Re: Petition No. 1484 – Modifications to Gales Ferry Substation

Responses to CSC-01 Interrogatories, dated February 22, 2022
CSC-01 through CSC-013.

EVERSOURCE ENERGY
GALES FERRY 11B
SITE DEVELOPMENT PLAN
CIVIL PLAN & DETAILS
LEDYARD, CT
17202-11005 PG.1

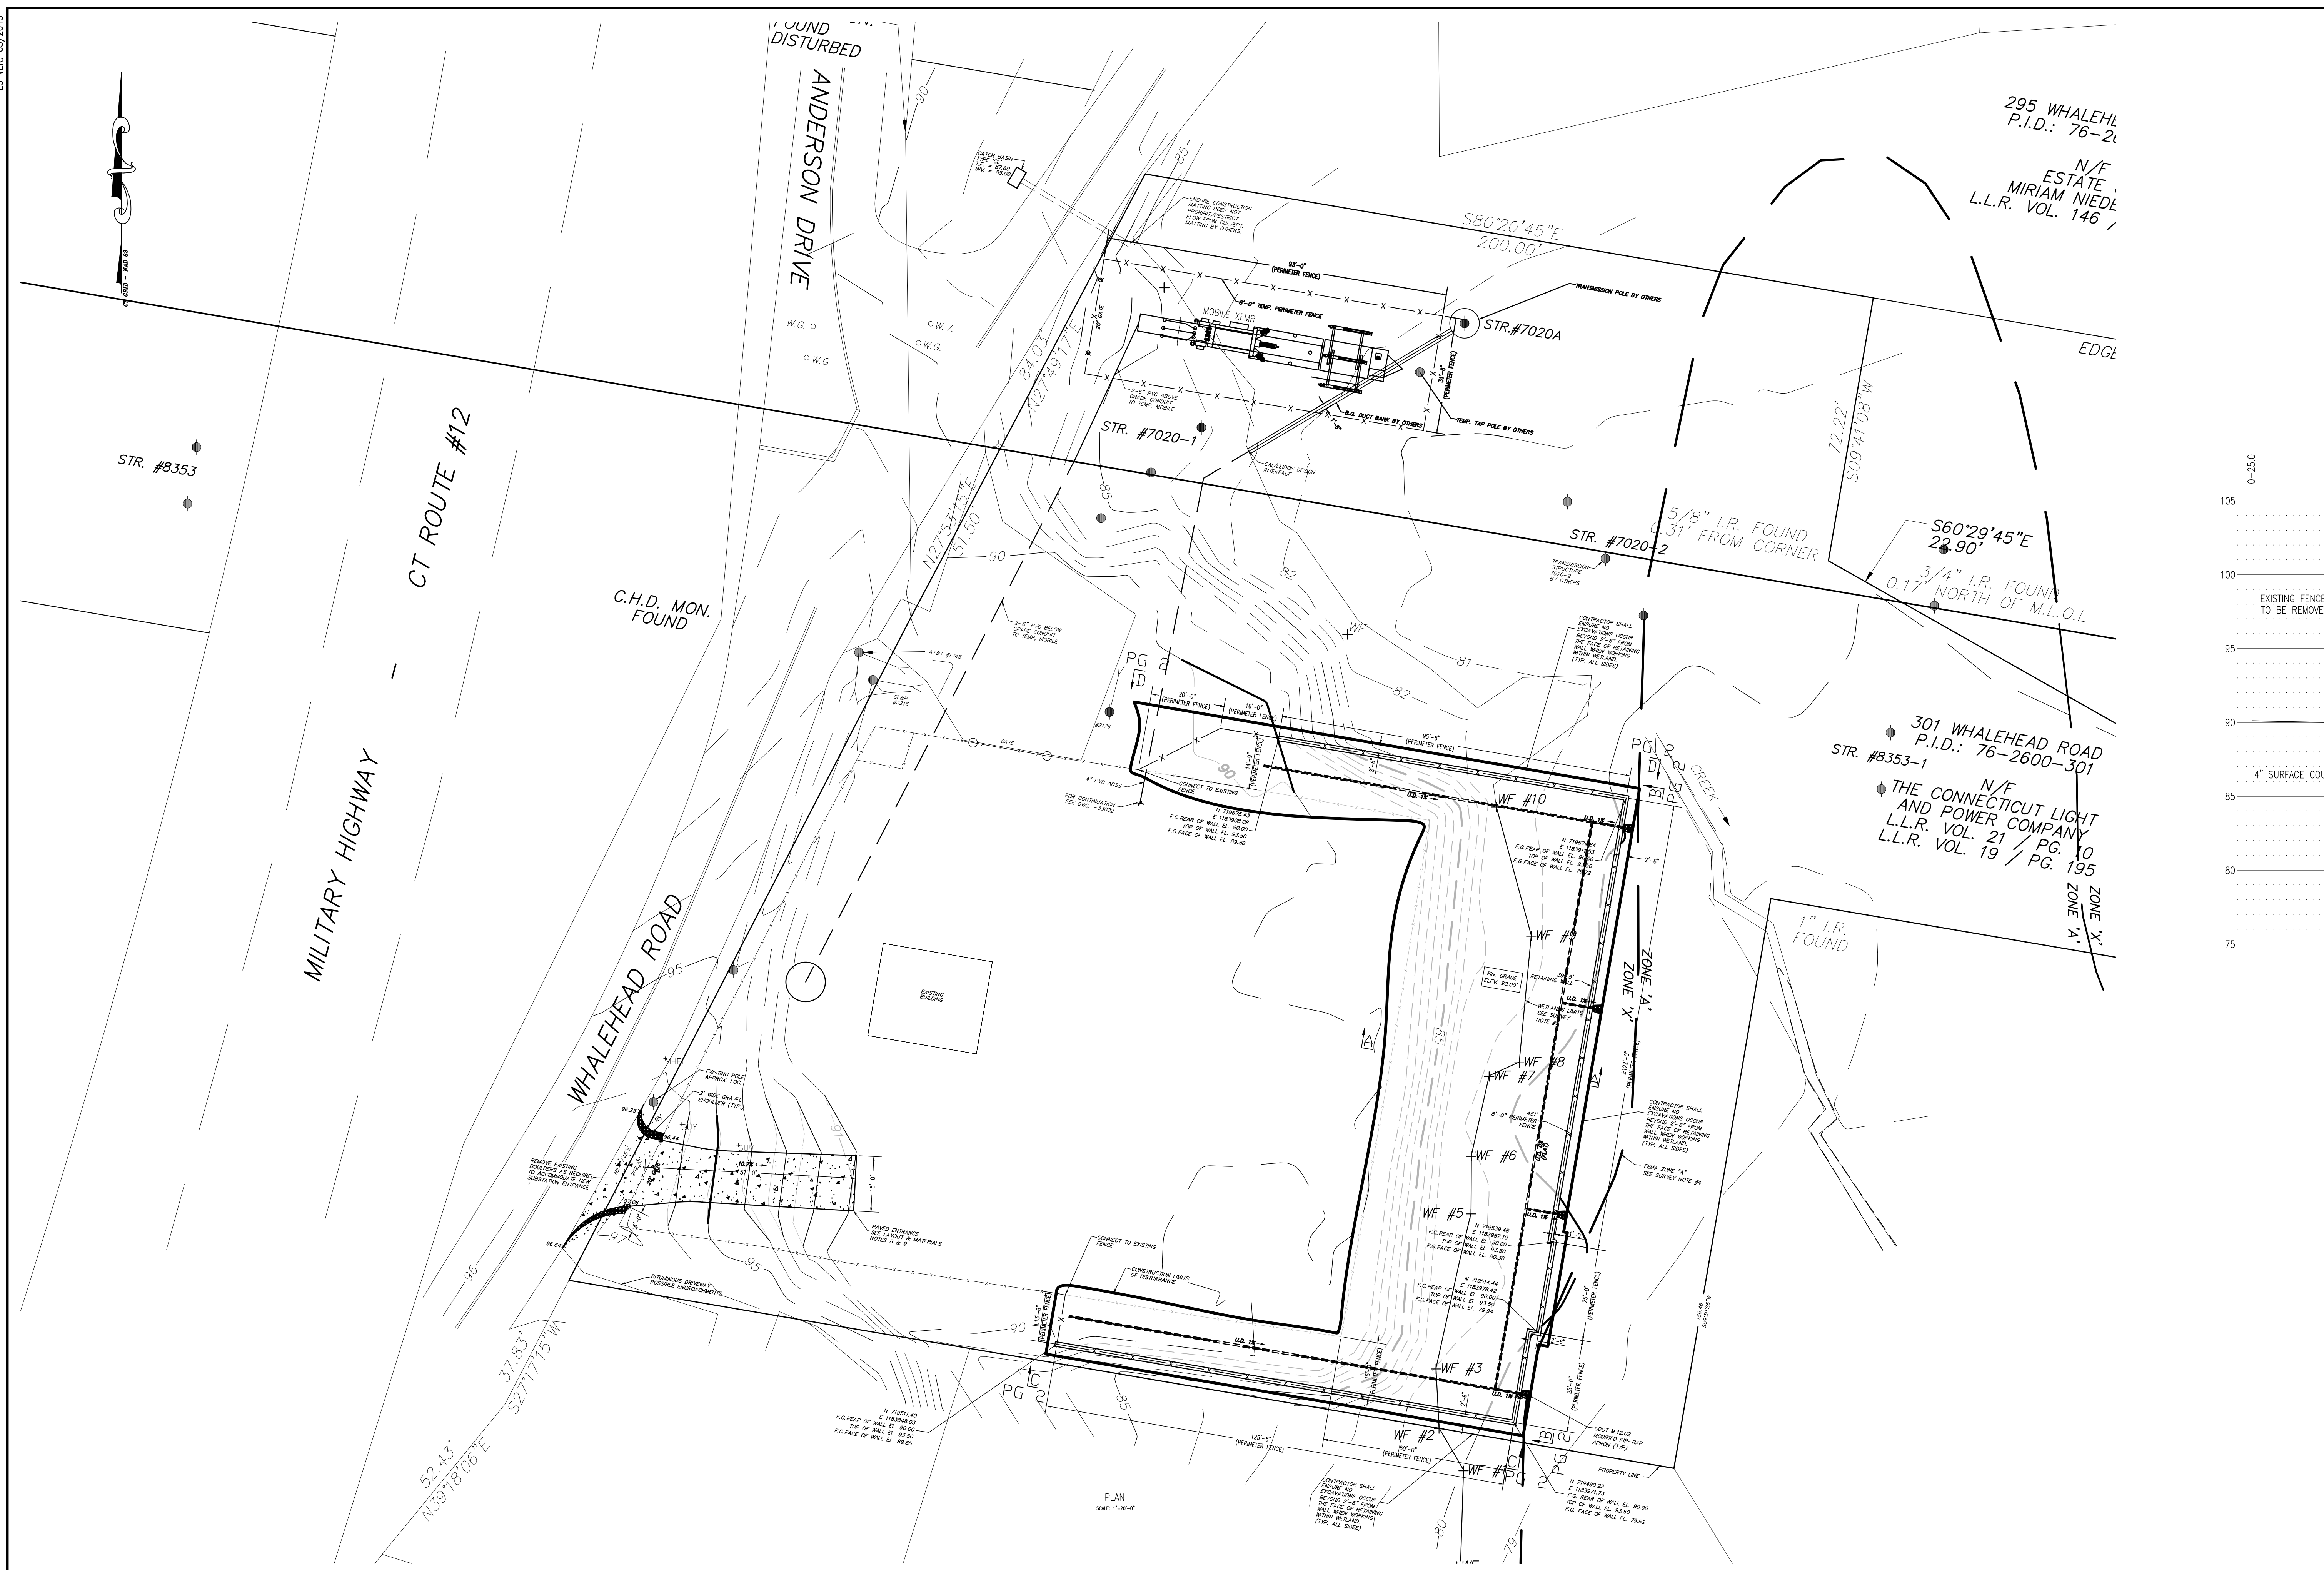
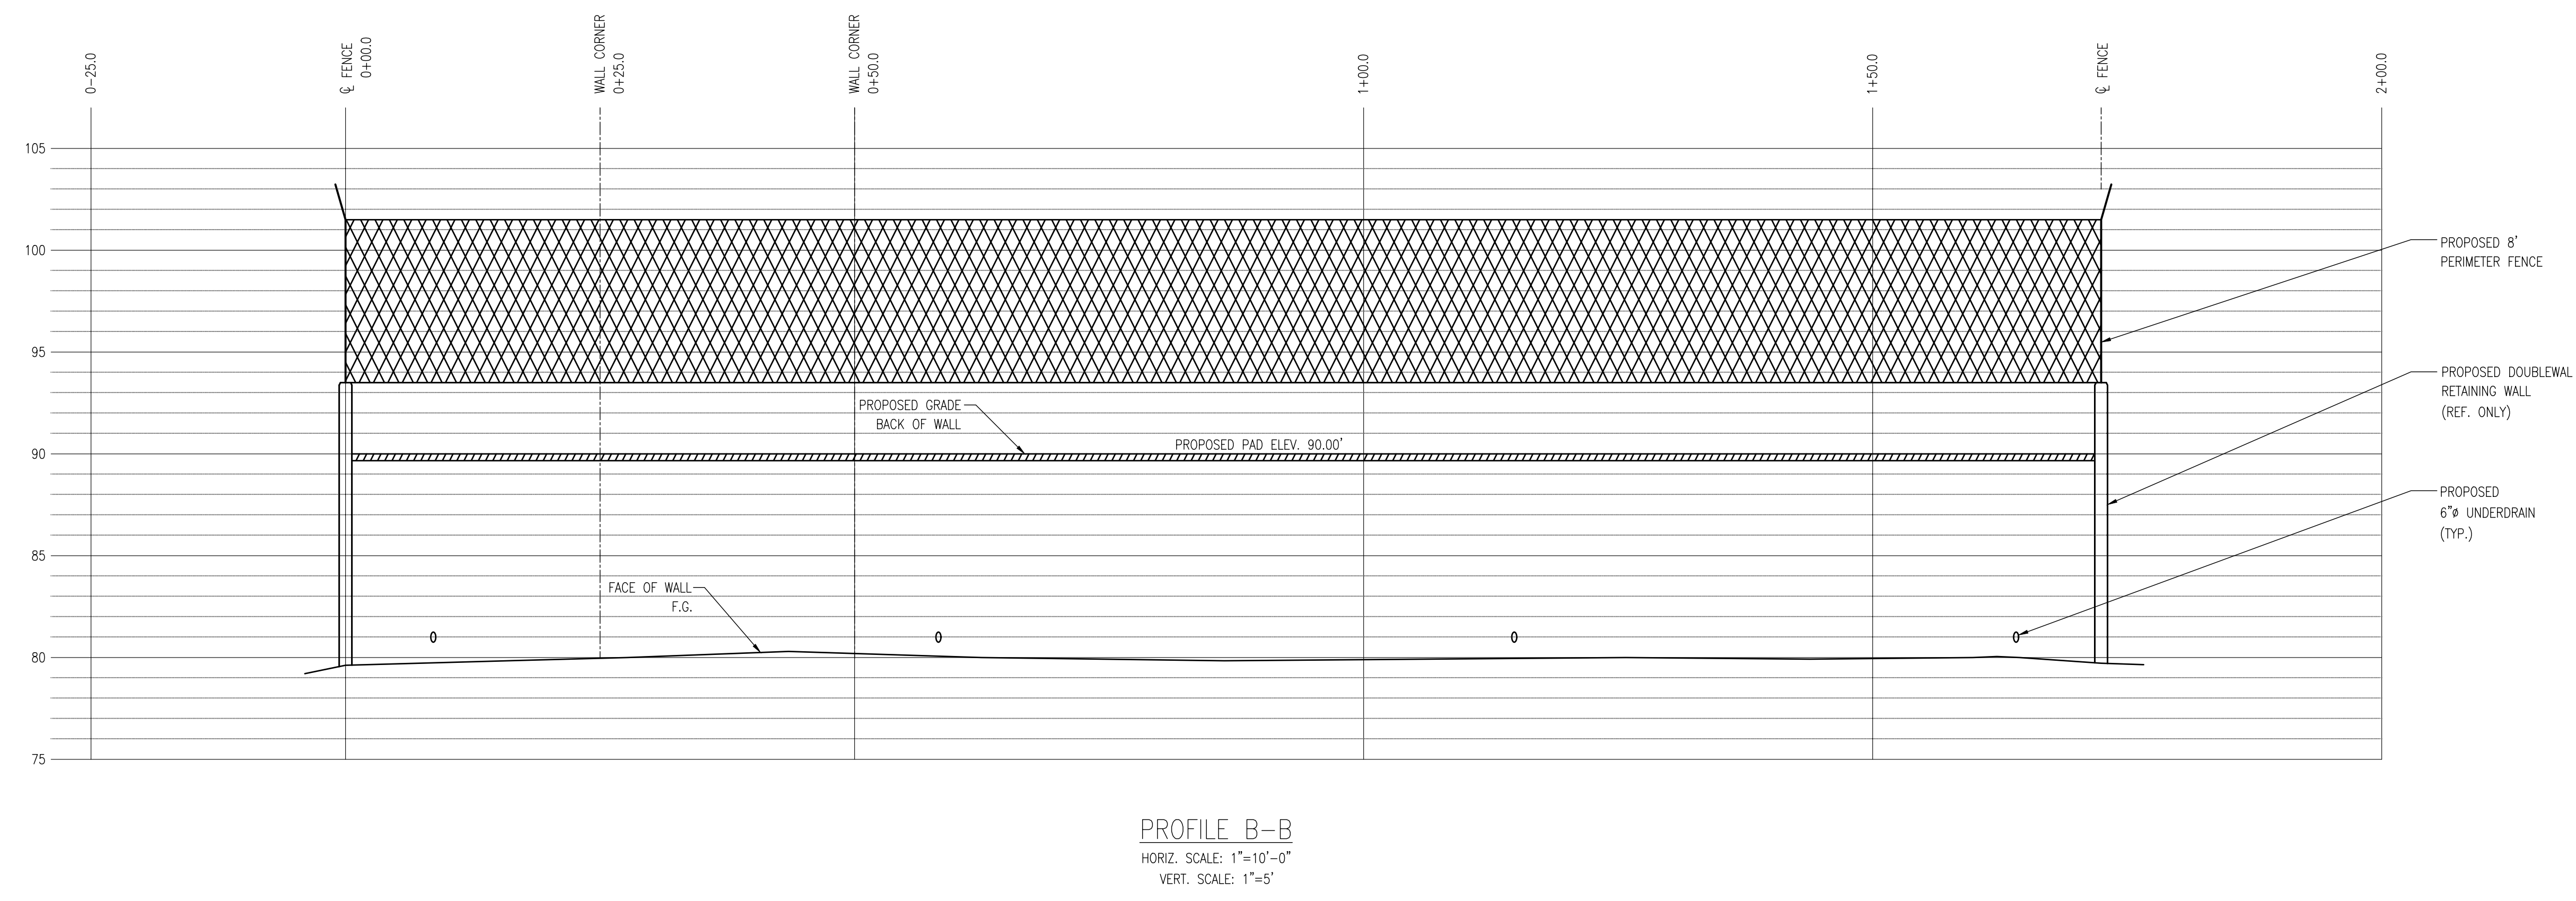
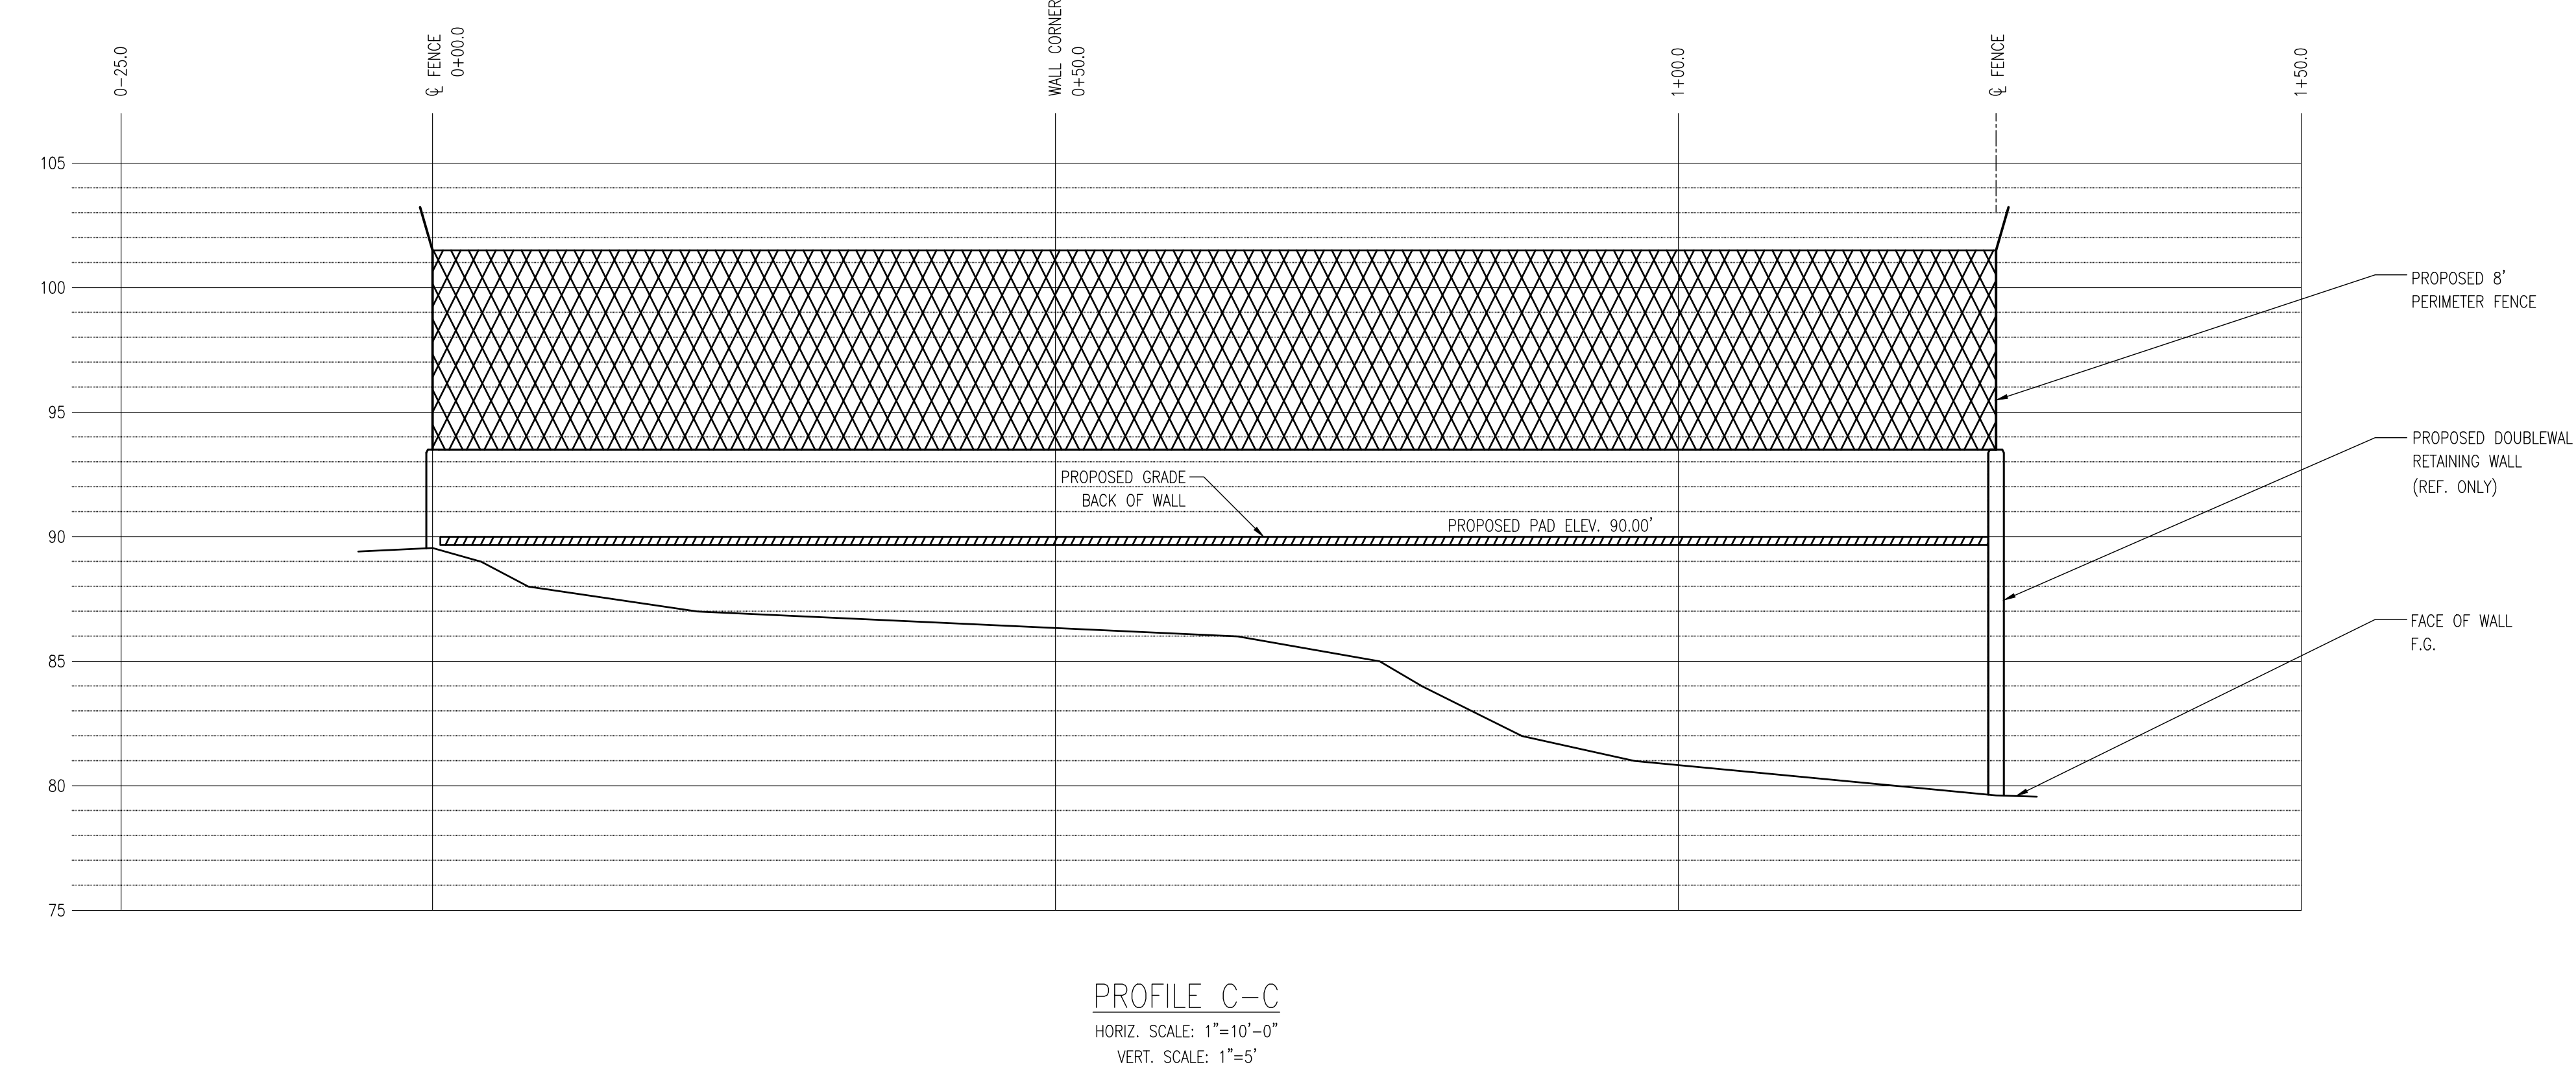
Provide a drawing of the proposed retaining wall.

Drawings showing a plan view and cross-sections of the retaining wall are attached.
